RE: Response to Submissions – PA2024/0392
At: Lot 03981 Town of Darwin (17 Harry Chan Avenue, Darwin City)

1.0 Further Information

Via request dated 16 January 2025, Development Assessment Services requested further information to enable assessment of the application to continue. The amended plan set attached hereto addresses the architectural components of the requested further information / clarification. The request items are included in italics below, with the applicant's response to each item contained immediately thereafter.

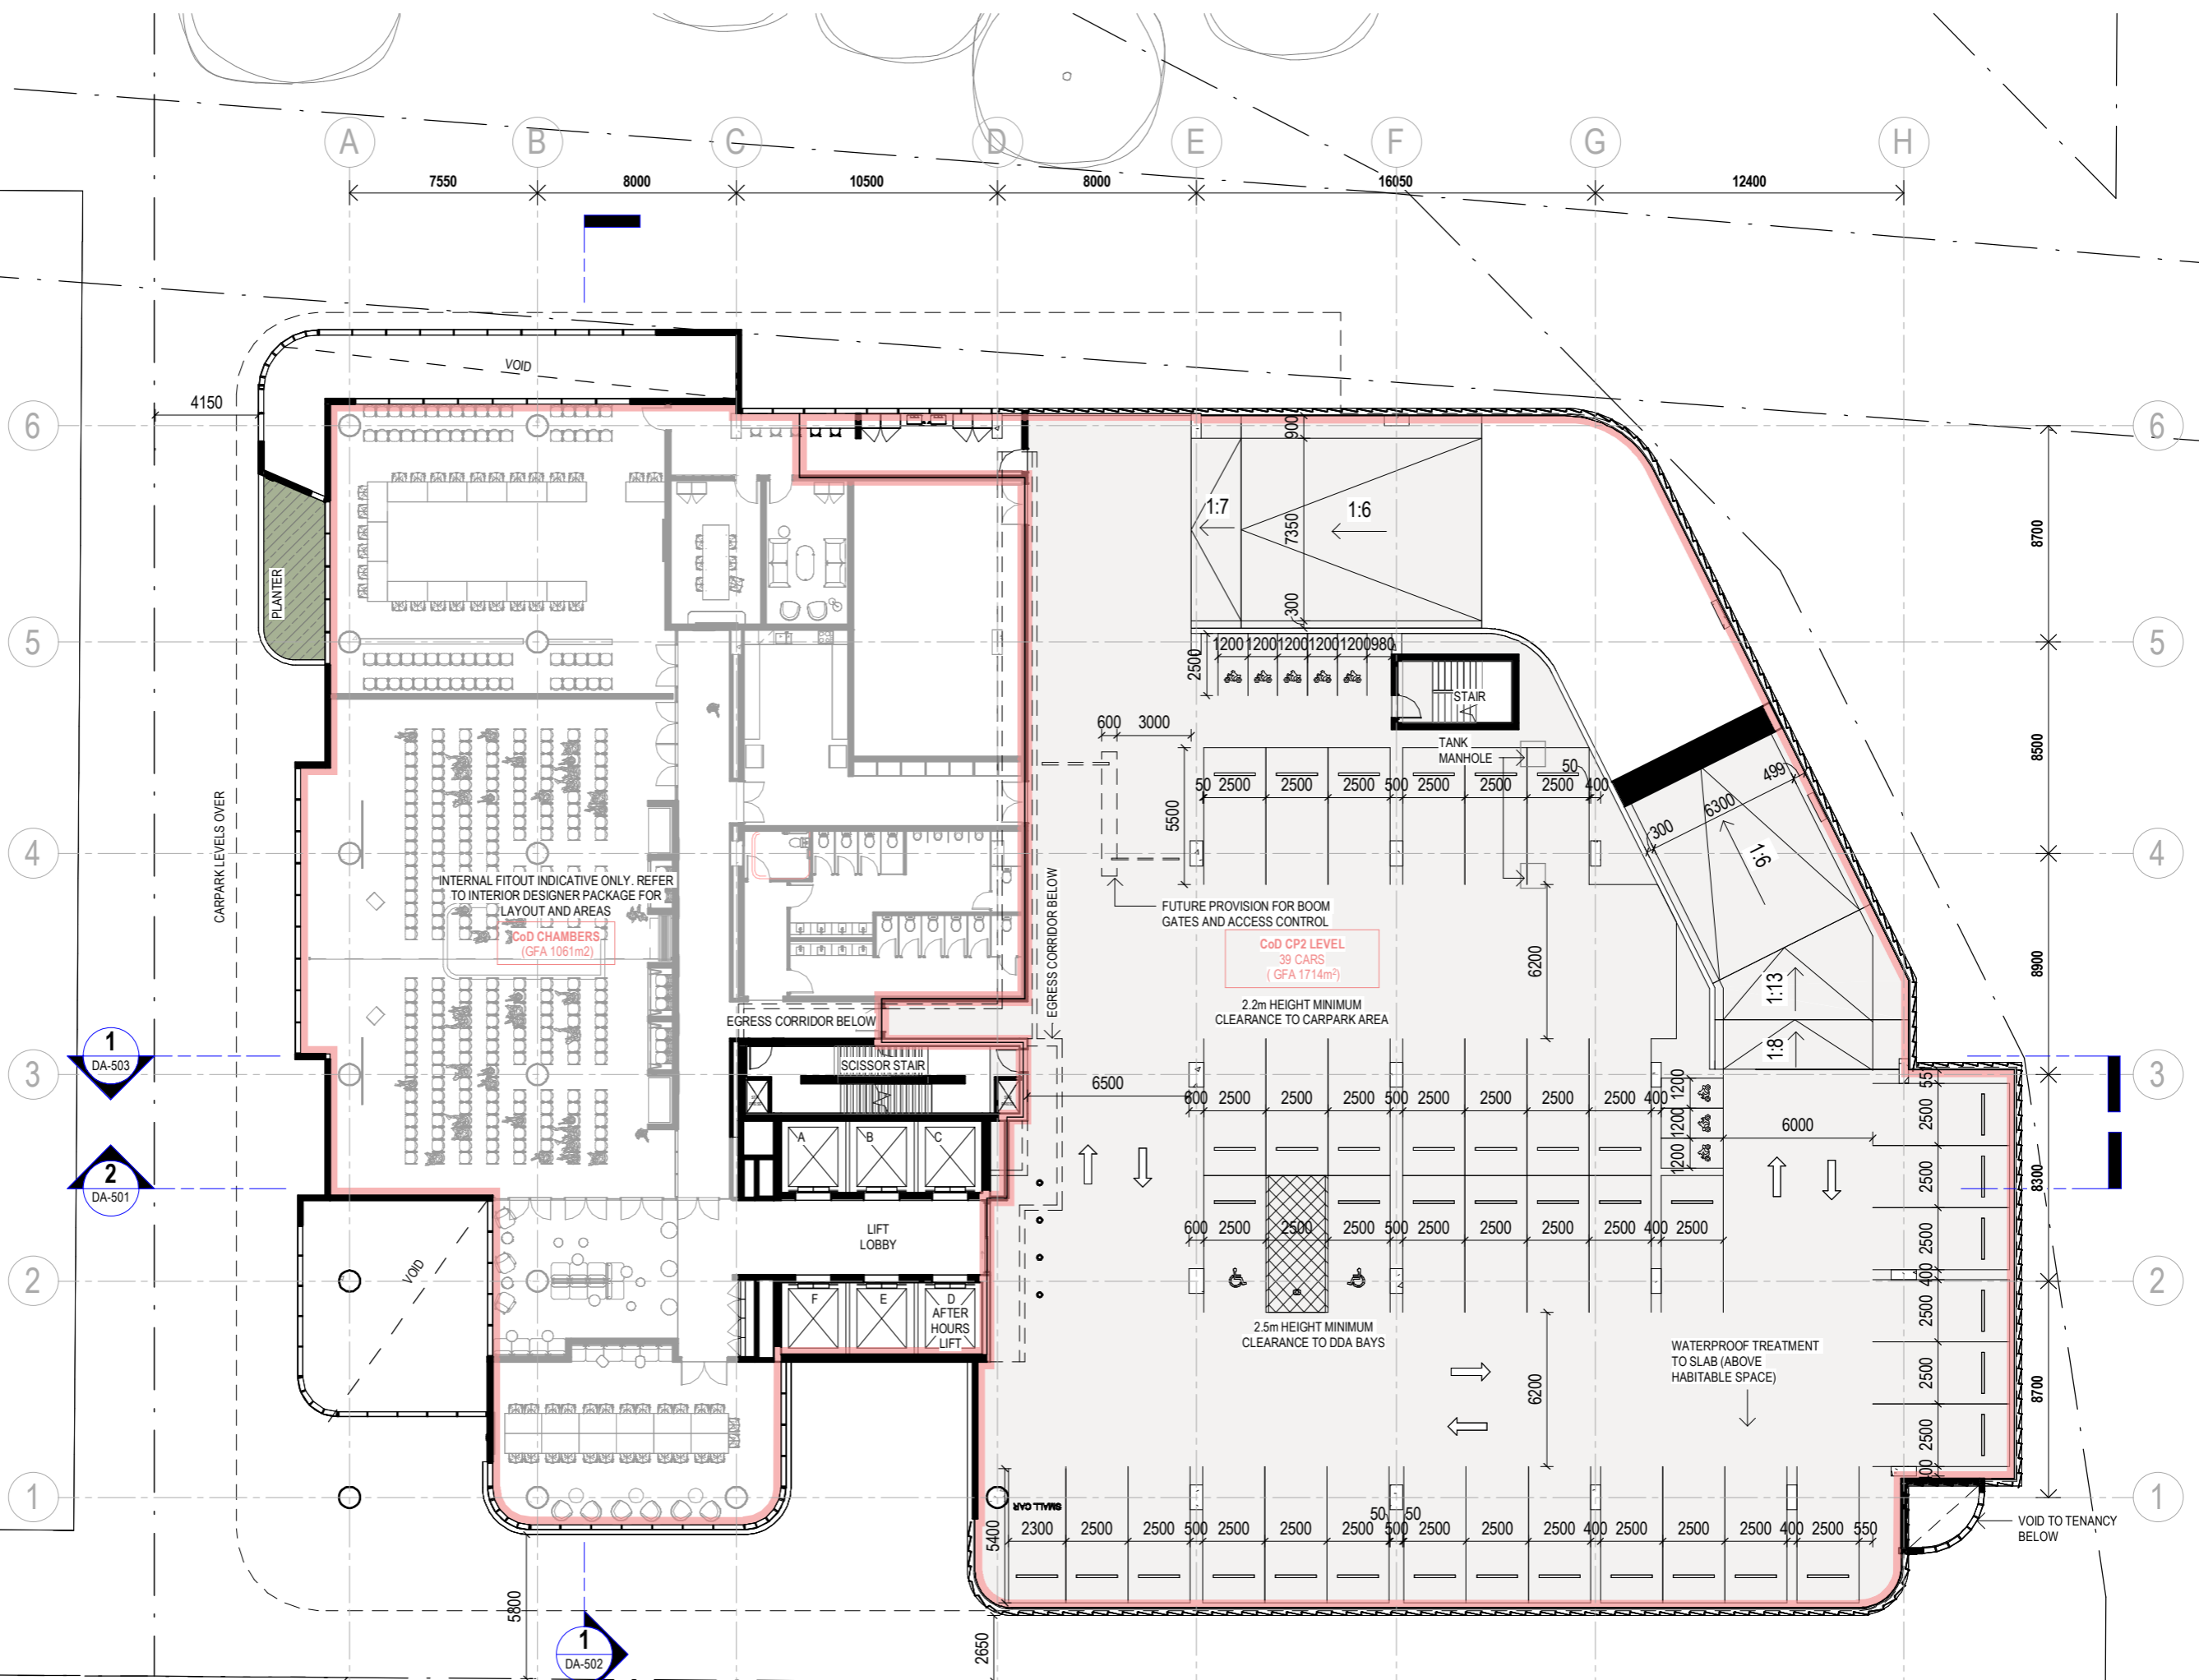
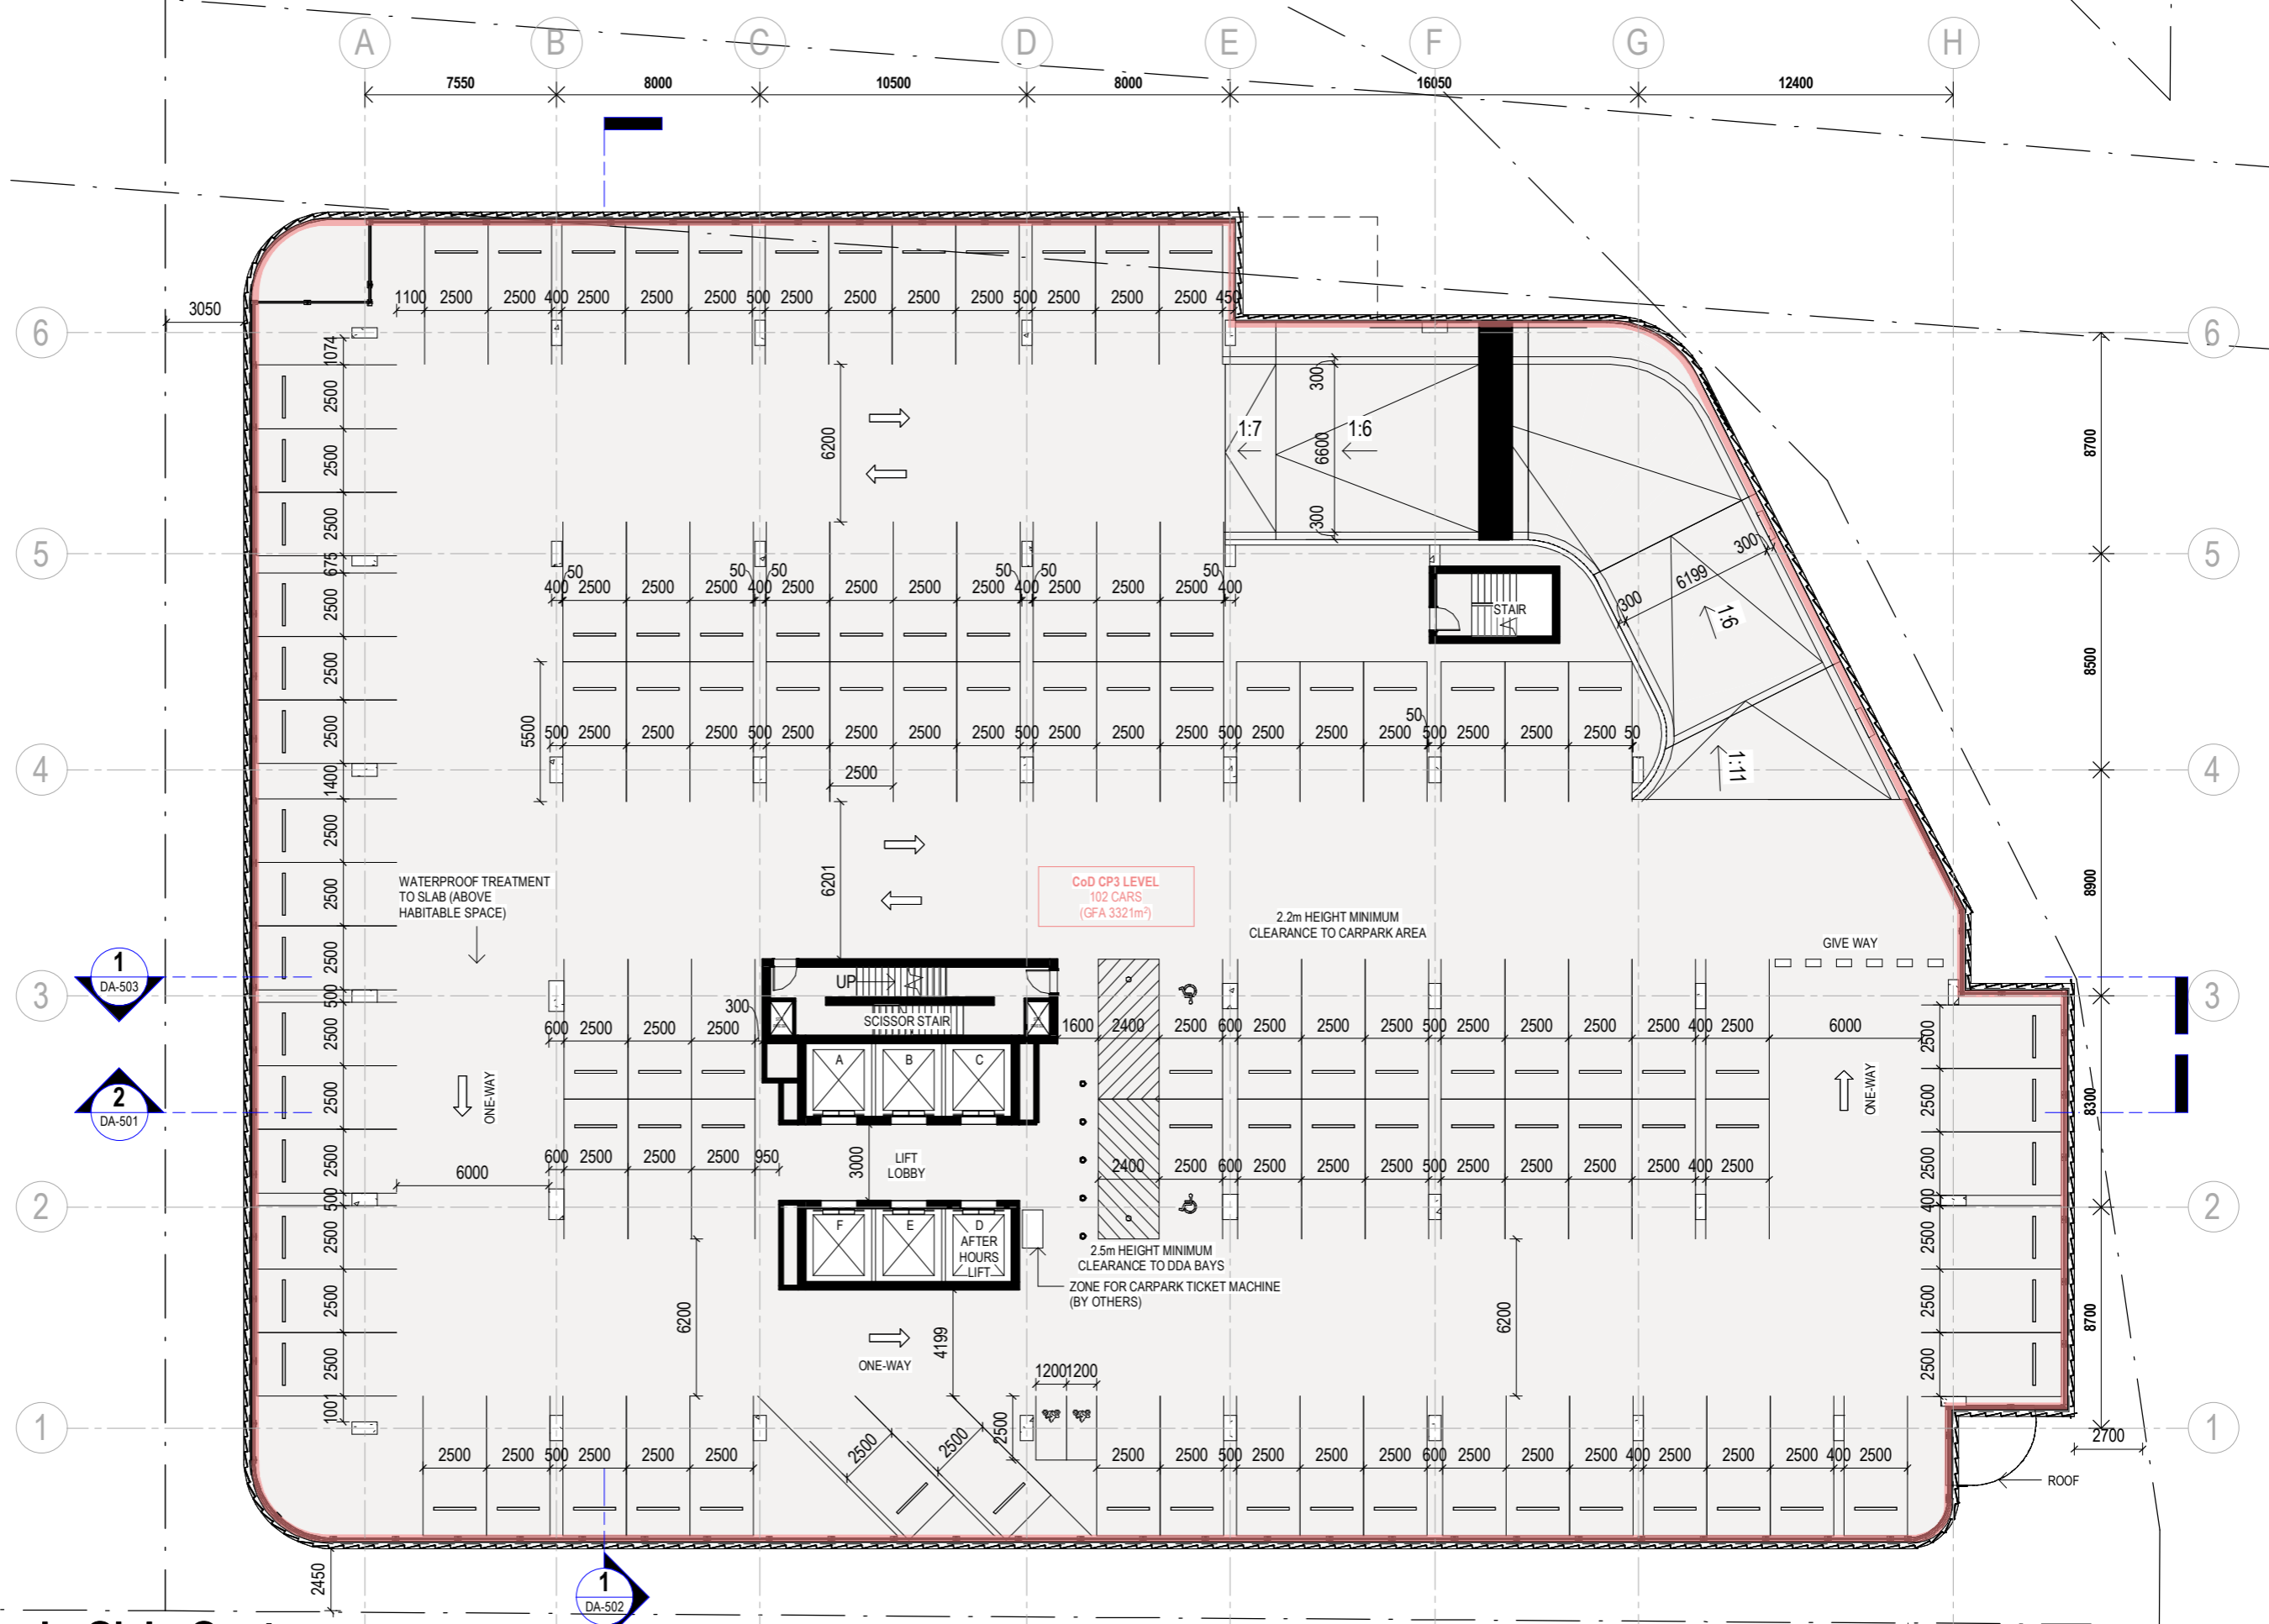
- *Update drawing DA-103 – DA – 106 to dimension the small car parking spaces and to clarify if the column encroaches into the southern corner car parking space at all levels. Can be addressed via permit conditions.*

The car parking table on DA-103 – 106 indicates the dimensions of the 2 proposed small car parking spaces (2.3m x 5.4m and 2.3m x 5.0m). Drawings have been updated to confirm that the columns do not encroach into the car parking spaces.
